UNITED STATES PATENT AND TRADEMARK OFFICE

APPLICATION NO.	FILING DATE	FIRST NAMED INVENTOR	ATTORNEY DOCKET NO.	CONFIRMATION NO.
10/735,783	12/16/2003	Hsia-Hui Chen	MR1197-598	4117

Office Action Summary	Application No.	Applicant(s)	
	10/735,783	CHEN, HSIA-HUI	
	Examiner	Art Unit	
	Winnie Yip	3636

Part II DETAILED ACTION

FIG. 3

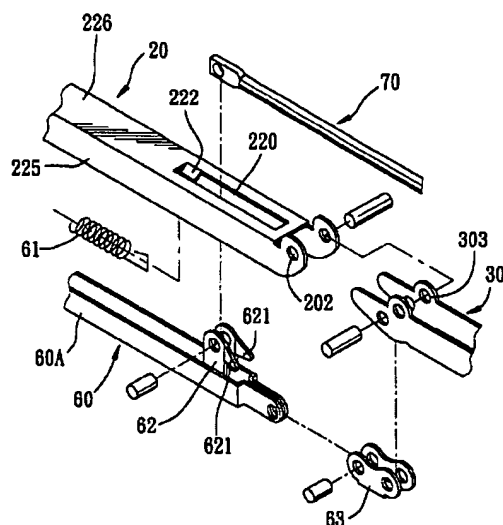
5. Claim 1 as better understood, stand rejected under 35 U.S.C. 102(b) as being anticipated by Wang (US Patent No. 6,244,284) .

Wang teaches a multiple-fold umbrella comprising a plurality of ribs, each rib having a multiple pivotally joined rib sections (i.e., 30, 20), a joint being pivotally coupled between two rib sections, the joint having a wide base (63) and pins (P1, P2, P3), the joint being pivotally coupled to one rib section (30) by two pins (P1, P2) (see illustration bellow), one of the two pins (P2) being pivotally coupled to another rib section (20), the two pivotally coupled rib sections being positioned, counted from outside, in side by side relationship within the base of the joint in collision (see Fig, 6).
